Open issues with Clause 93

IEEE P802.3bj Task Force
November 2012

Table 93–8, transmitter output voltage and bandwidth

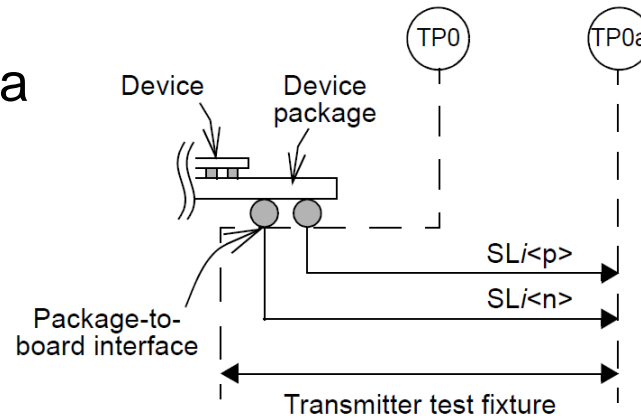
- $0.4\text{ V} < v_f < 0.6\text{ V}$, peak value of $p(k) \geq 0.8 * v_f$ (see 93.8.1.6.1)

- Measured at TP0a

- Emulate in COM framework

Test fixture filter

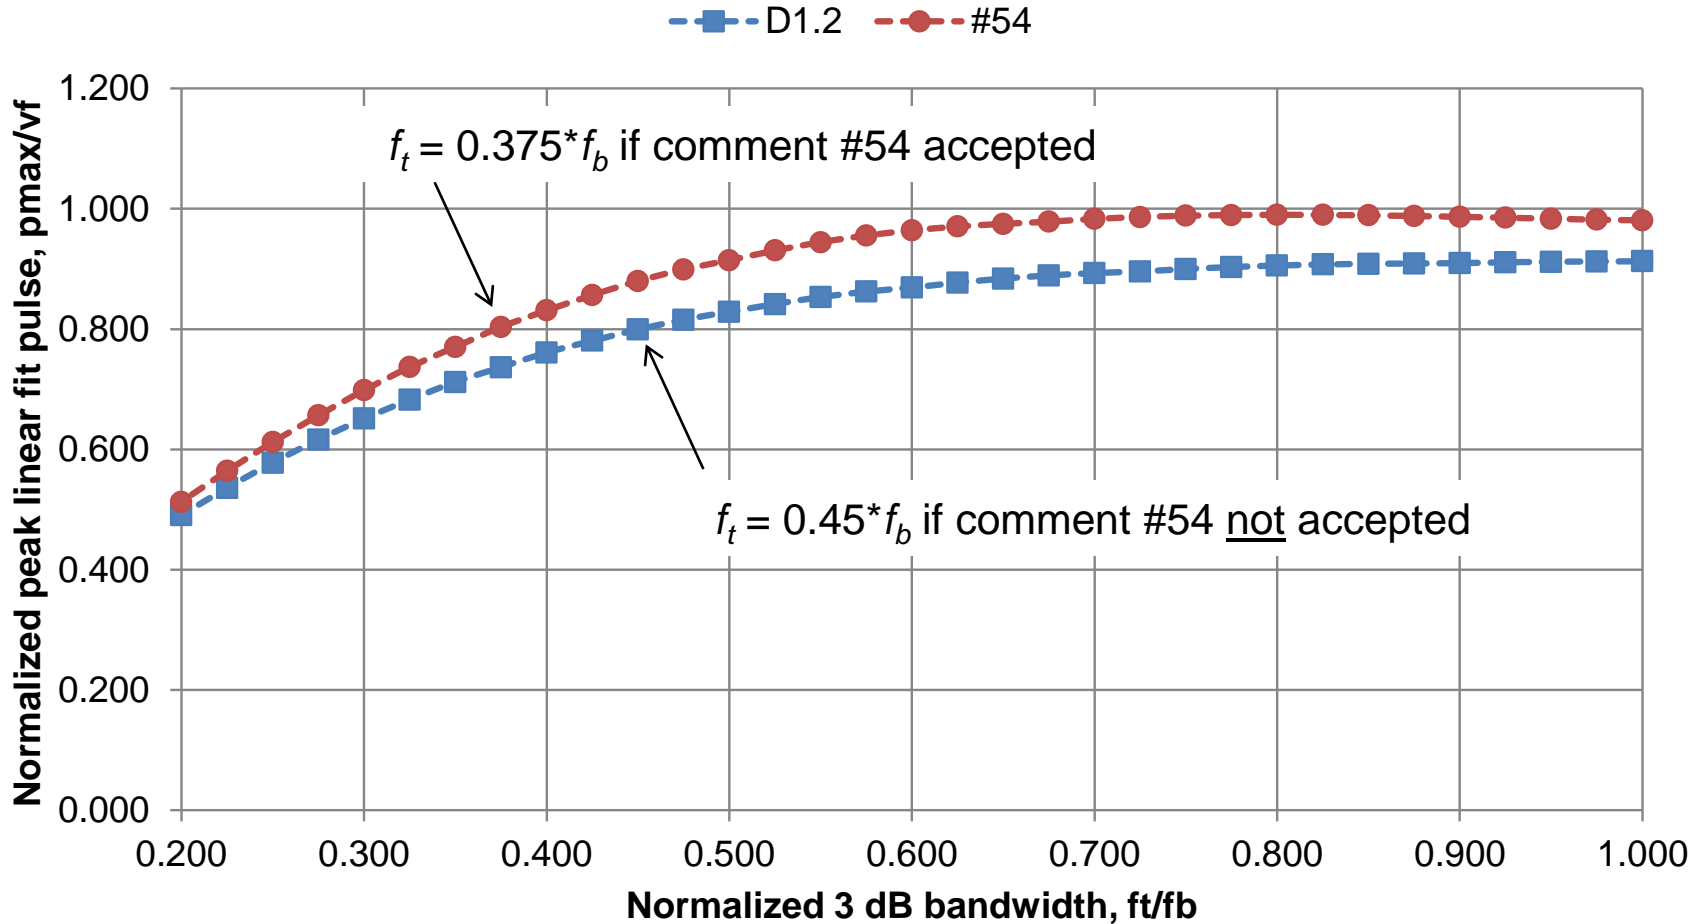
- Transmission line with 1.2 dB insertion loss at 12.89 GHz
 - 100 Ohm differential impedance
- Terminate fixture with reference load, Γ_2 is 0
- $H_{21}(f)$ reduces to transmission line $s_{21}(f)$, Γ_1 irrelevant

Achieving peak value of $p(k) \geq 0.8 * v_f$

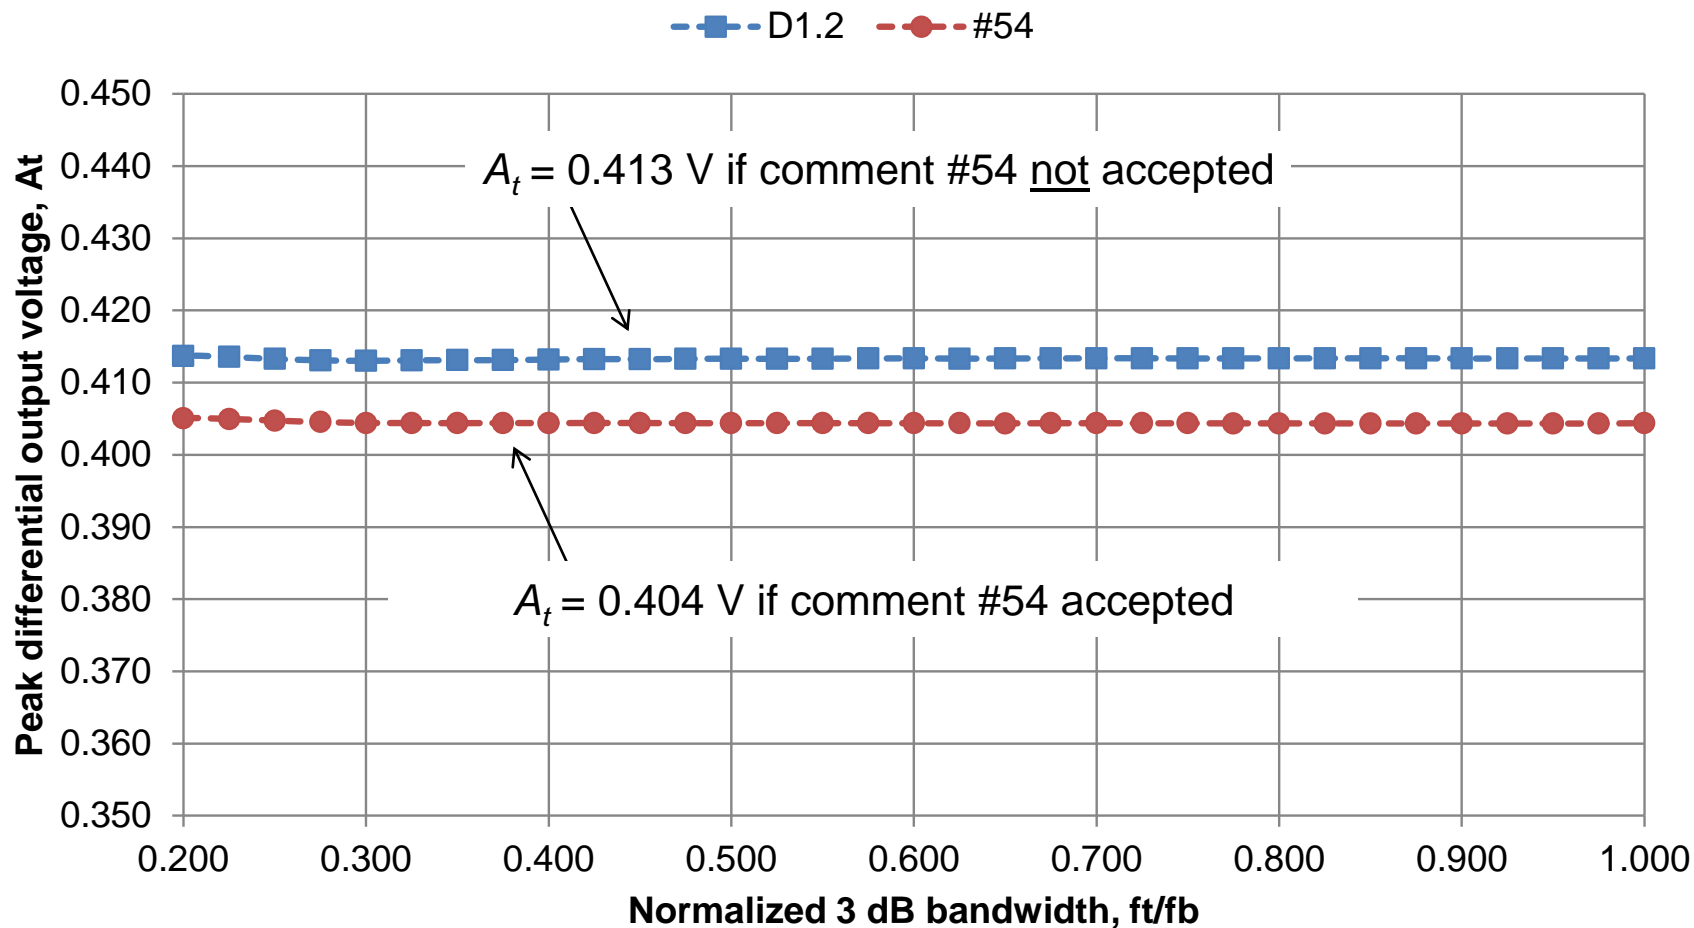
Achieving $v_f = 0.4$ V

Table 93–8, transmitter equalizer

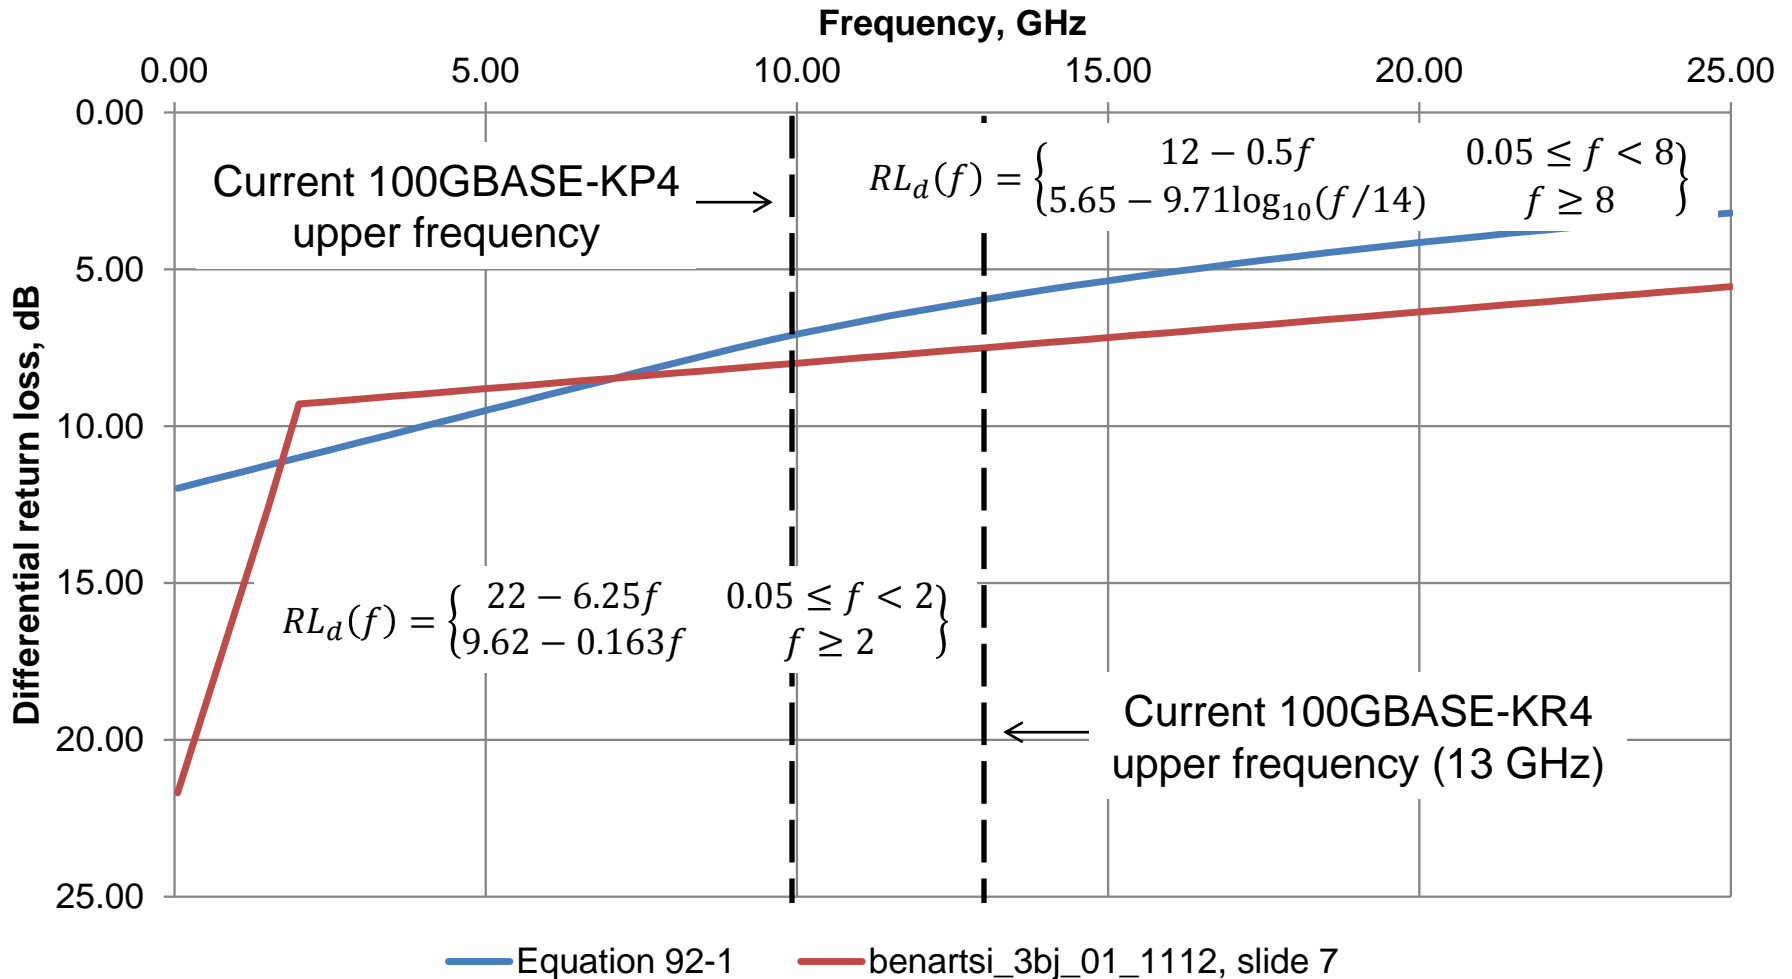
- Set $c(-1)$ and $c(1)$ step size to 0.05 (see 93.8.1.6.4)
- Coefficient range (see 93.8.1.6.5)
 - $(c(0)-c(1))/(c(0)+c(1))$ shall be greater than or equal to 4, $c(-1) = 0$
 - $(c(0)-c(-1))/(c(0)+c(-1))$ shall be greater than or equal to 1.54, $c(1) = 0$
 - $c(0)-c(-1)-c(1) = 1$ for $c(-1) \leq 0$, $c(1) \leq 0$ (see 93A.1.3.4)
- Set minimum $c(1)$ to $-0.4 = -8*0.05$
 - $c(1) = (1-R_{pst})/(2*R_{pst}) = -3/8$
- Set minimum $c(-1)$ to $-0.2 = -4*0.05$
 - $c(-1) = (1-R_{pre})/(2*R_{pre}) = -0.54/3.08$

- If comment #54 is accepted, in Table 93–8...
- ...set $f_v = f_f = 0.375 * f_b$

- If comment #54 is not accepted, in Table 93–8...
- ...set $A_v = A_f = 0.41$ V and...
- ...set $f_v = f_f = 0.45 * f_b$

- In Table 93–8, update transmitter equalizer pre- and post-cursor coefficient minimum value and step size
